## DONCASTER METROPOLITAN BOROUGH COUNCIL

### PLANNING COMMITTEE -6<sup>th</sup> Feb 2018

<b>Application Number:</b>	17/02591/FUL	<b>Application Expiry Date:</b>	13th December 2017
----------------------------	--------------	---------------------------------	--------------------

<b>Proposal Description:</b>	Erection of two storey dwelling and detached double garage.
<b>At:</b>	69 High Street Hatfield Doncaster DN7 6RS

**Appendix 1 – Previously approved 16/00634**

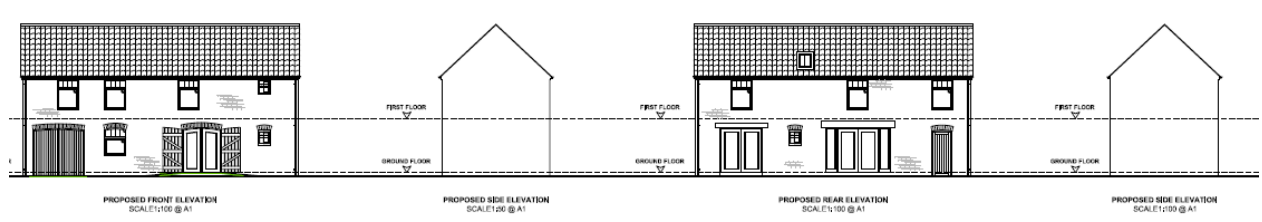
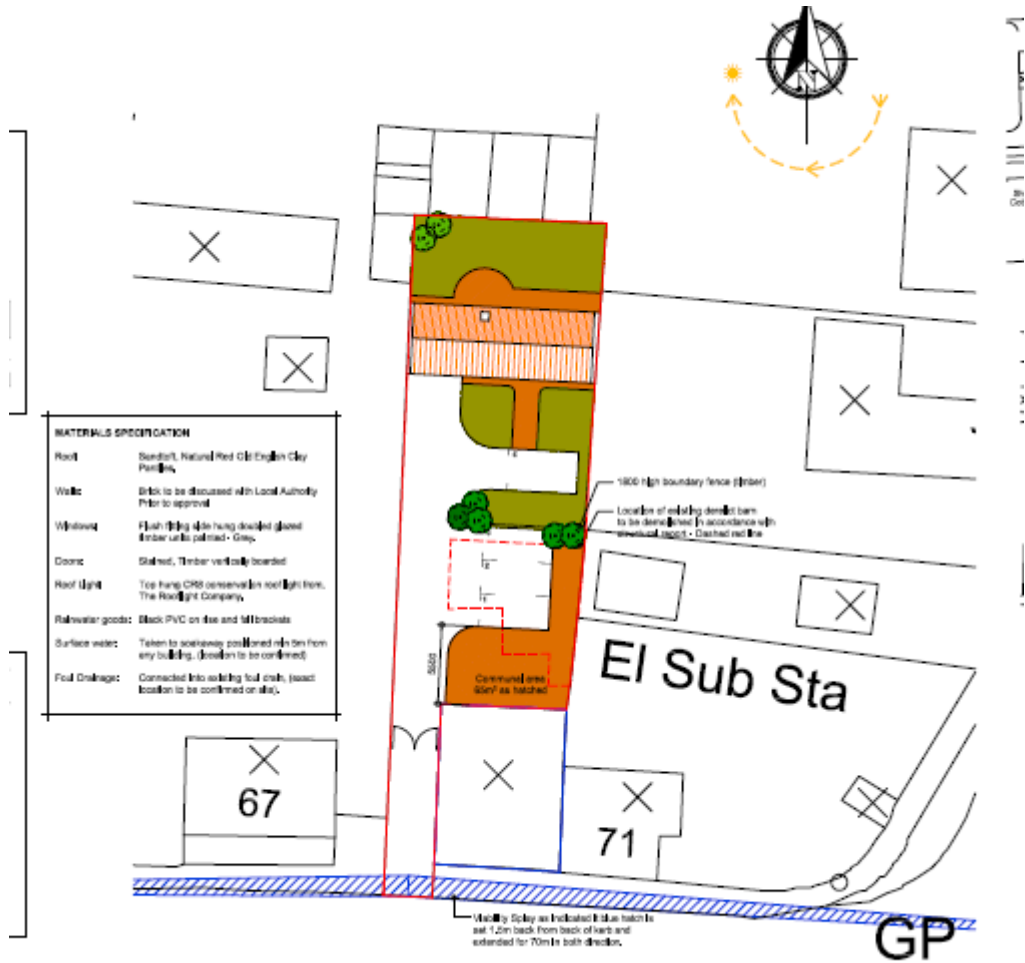
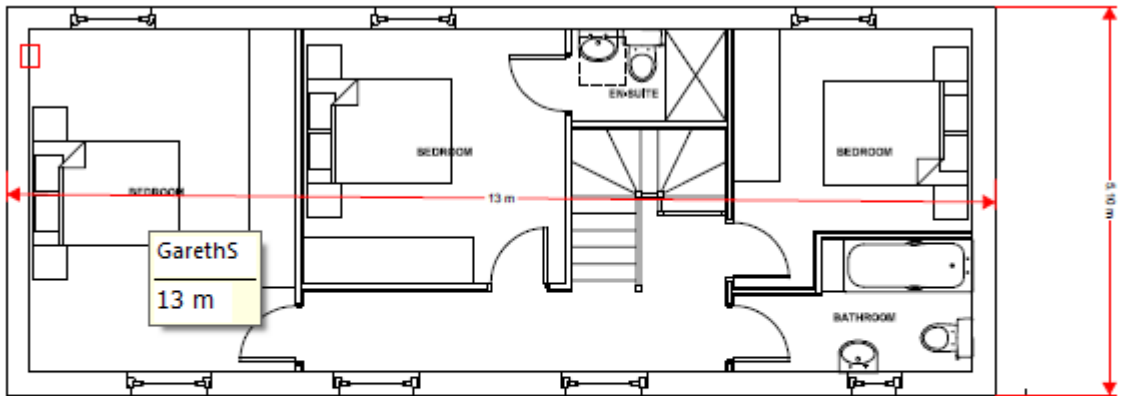
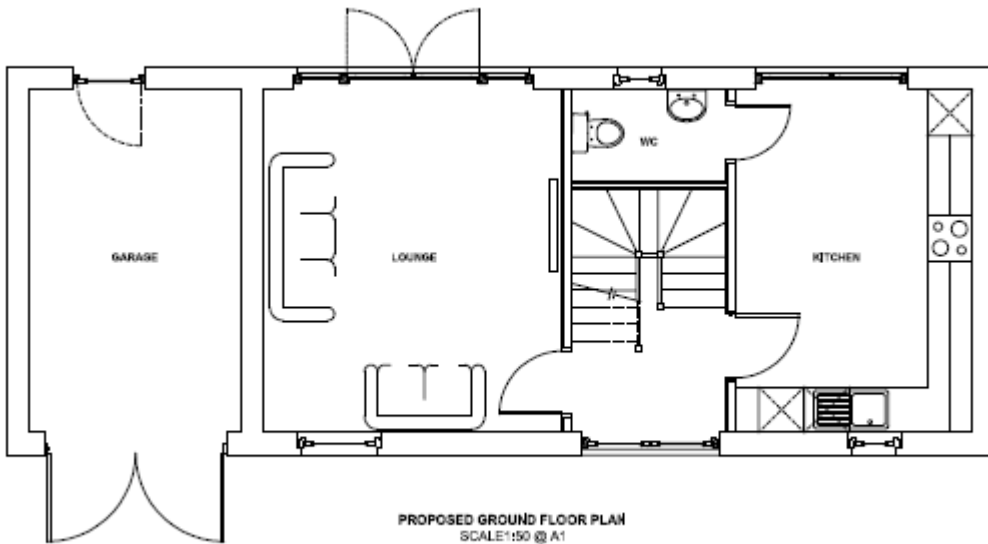
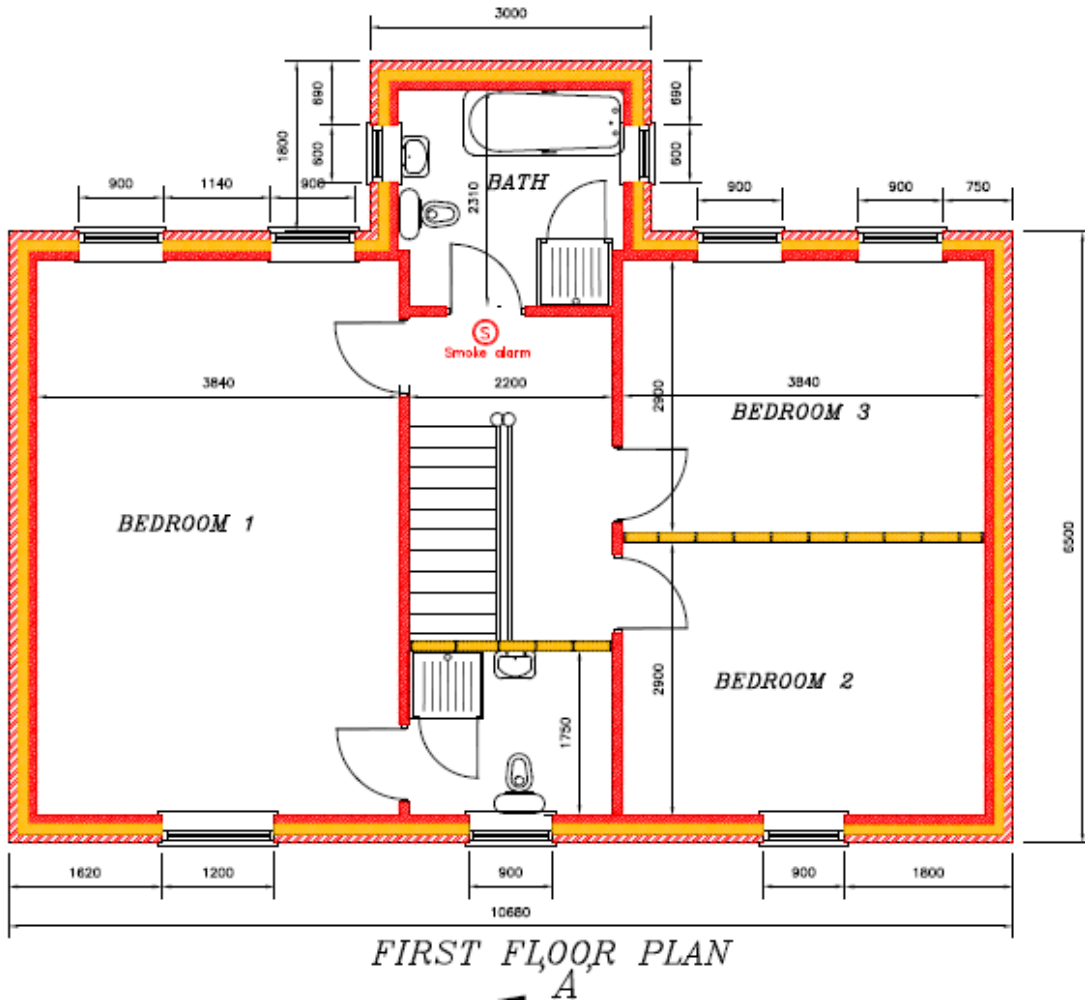
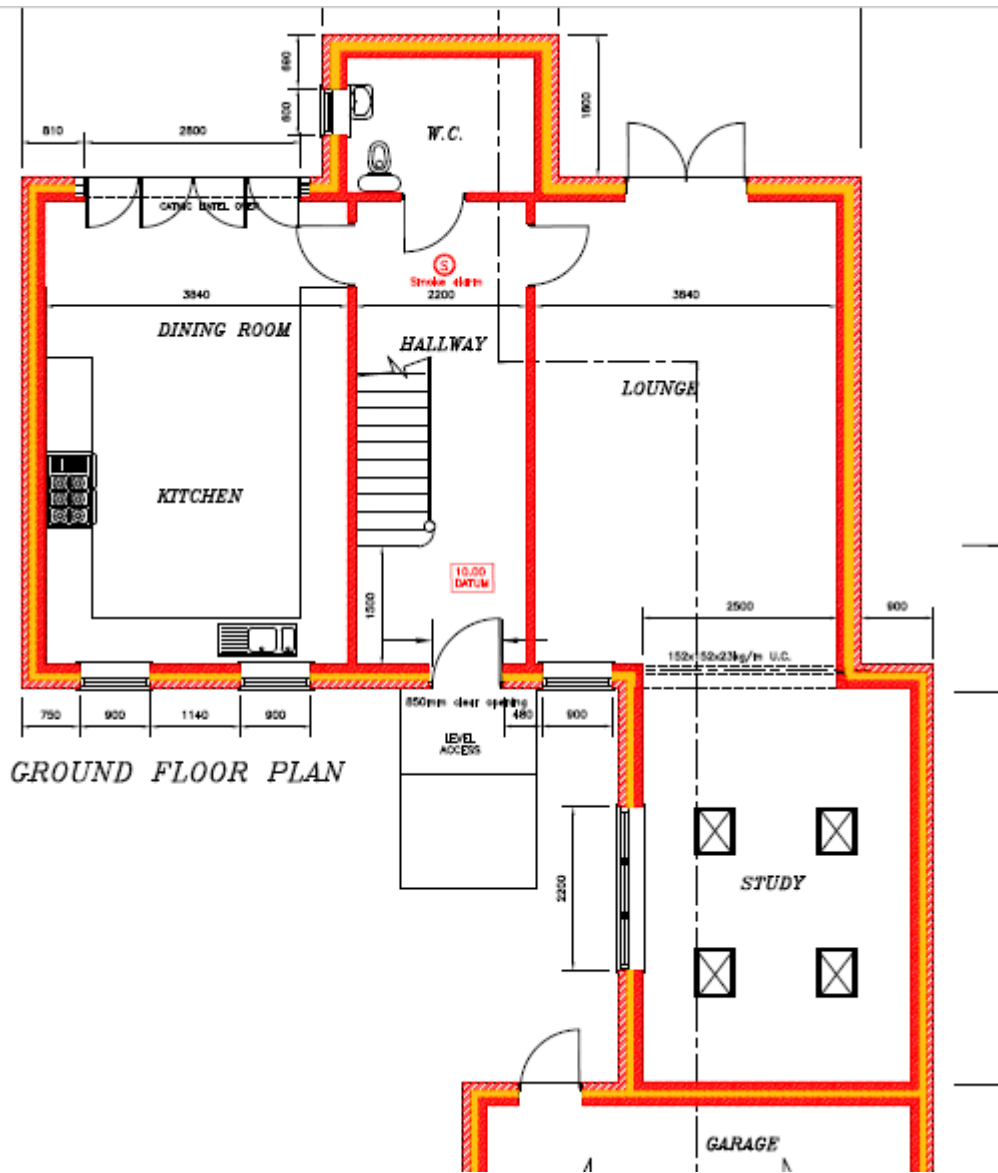
8.5 The extant approval permitted a narrow span barn like structure, designed to replicate the building that was demolished. The building had a depth of 5.1m and spanned the entire width of the plot being 13m. The dwelling had a ridge height of 7m and eaves height of 4.6m. The dwelling had an integral ground floor garage, lounge and kitchen diner, with 3 bedrooms at first floor and family bathroom. The dwelling was compact with a floor area of 66.3 sqm. The sides had blank gables with windows facing front to rear. (Shown in Appendix 1)

**Appendix 2 – Current plans**

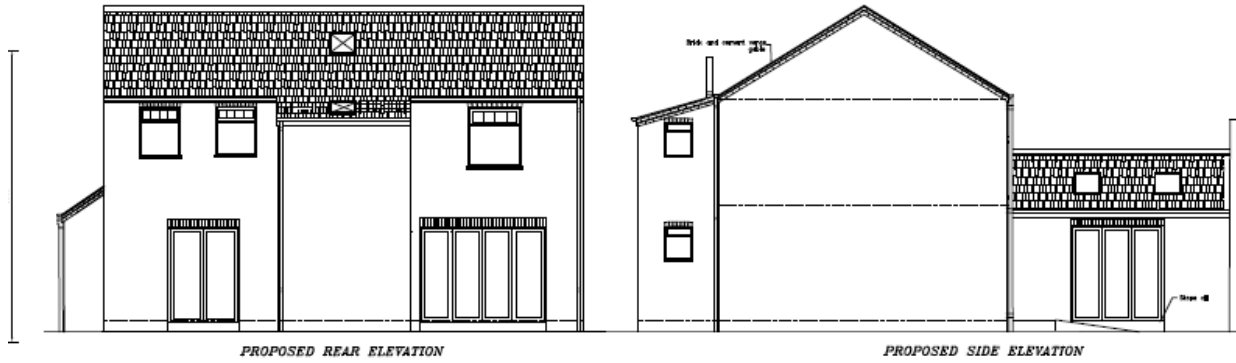
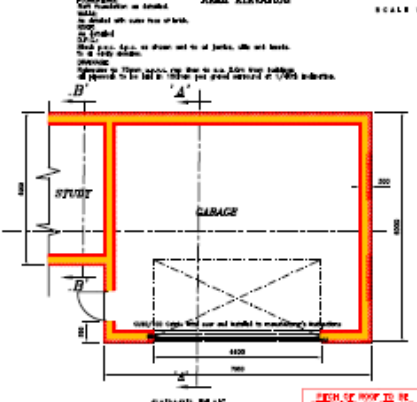
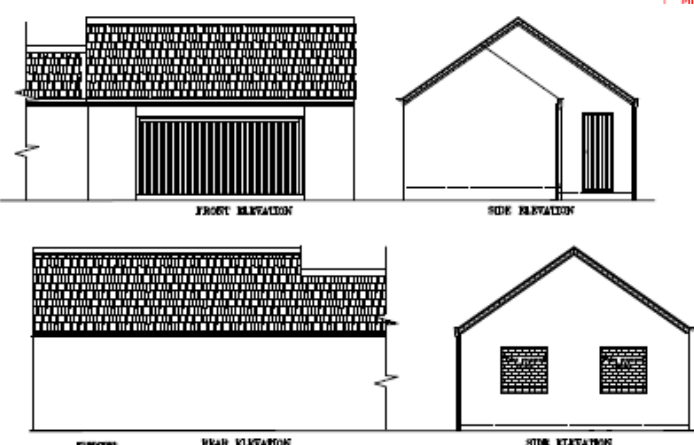
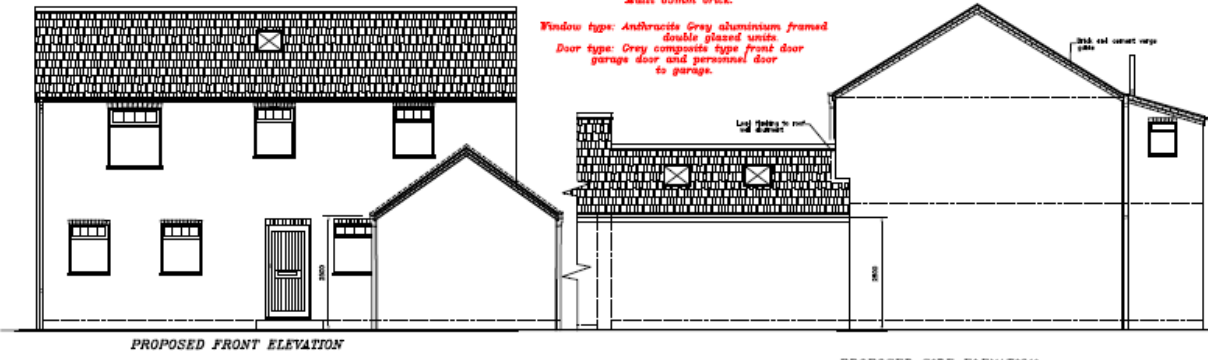
8.7 The applicant was advised that this would not be supported and through several amendments a revised scheme was submitted. This further reduced the span of the building to 6.5m and the width to 10.3m. The detached garage was reduced to a double garage and butted up to the dwelling. A ground floor study and two storey rear extension were added with a cat slide roof. The chimney was removed, the windows and doors were improved giving the design a much more barn like in appearance. This actually increased the floor area to around 94m sq but the reconfiguration of the massing and the single storey nature of the additions assisted in lessening its actual impact. There is no question that this is a tightly compact dense development that is pushing the limitations of the site. With this in mind permitted development rights are recommended for removal to ensure the dwelling doesn't increase in size. The proposal also retains a reasonable sized rear garden.

8.12 The amendments made to reduce the span and width of the building and re detail the elevations make the building more traditional character and better reflect the barn design in the original approval. This lessens the overall impact and harm to the Conservation Area. The submitted single storey rear extension has been replaced by a 2 storey rear catslide extension of equivalent footprint which allows for a first floor bathroom. From a conservation viewpoint this detracts from the linear character and would be better to one side as opposed to the central location. However, it is less domestic than a gabled projection.

8.13 The separate garage has been relocated and integrated with the main building connected to it by a study and running along the side boundary. Again this arrangement is characteristic of backland buildings and agricultural ranges. This also gives better separation to the frontage building.

8.15 The proposal shows the windows with soldier course or shallow segment arch heads. Segment arches are fine but soldier course heads look unconvincing over significance spans (i.e. doorways) and a lintel appearance would be better. In the main the proposal is an improvement on the submitted scheme (notwithstanding the rear projection).

# Appendix 3 - Initial plans. (prior to amendment)

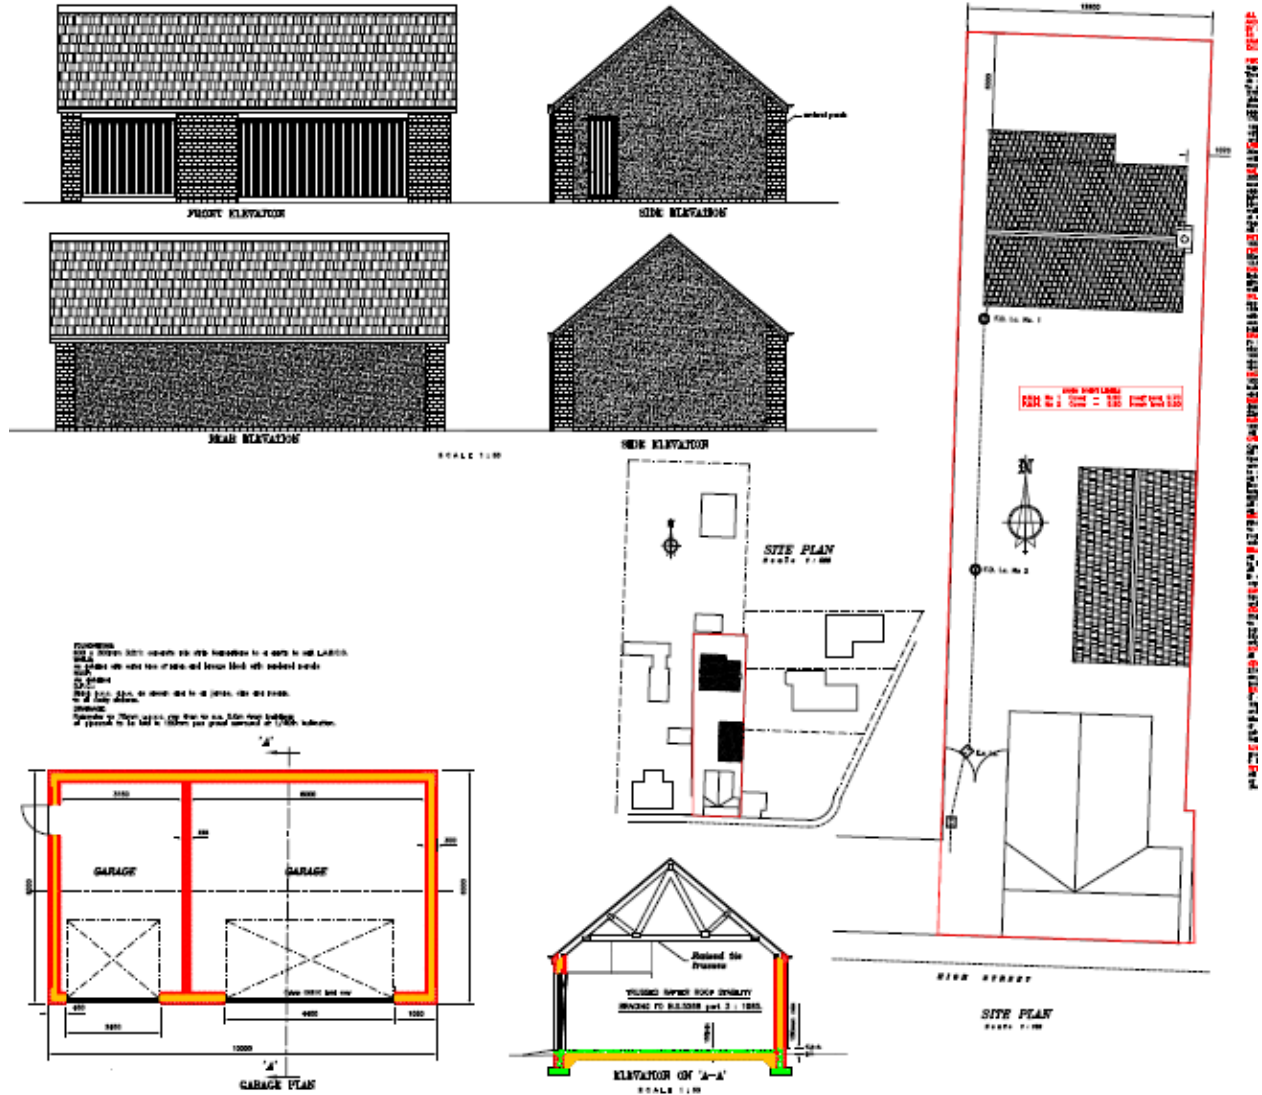
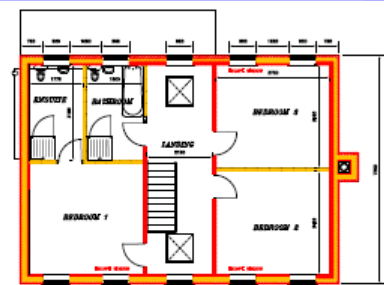
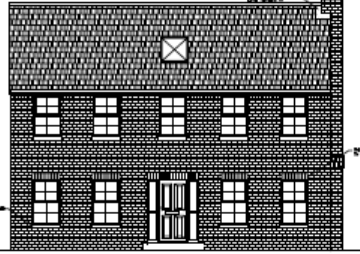
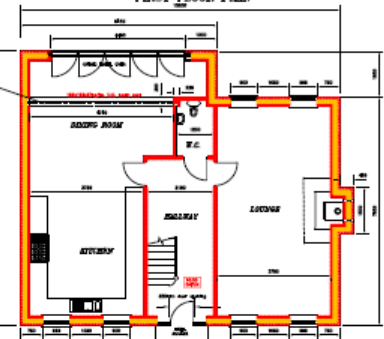
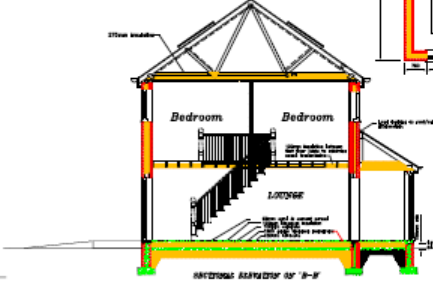
8.6 The proposed dwelling as originally submitted was designed more like a traditional house, with a central door way and sash windows. The foot print had increased to 88.4sqm. The depth of the dwelling was 7.5m with a 1.5m off shot at the rear compared with the narrower 5.1m previously permitted. The width of the dwelling was 10.5m so narrower than the 13m building previously permitted. The eaves height is 5.2m (compared with 4.5m previously permitted) and the ridge is 8.05m (compared with 7m). The dwelling is set slightly further back within the plot and proposed a detached triple garage.

8.11 The originally proposed building with its deeper span was a sizable (33%) increase in massing from that previously approved. Compounding this was the marked domestic appearance so that it could be perceived as a large backland house which goes against the spirit of earlier approvals and of the character of the conservation area as described above.
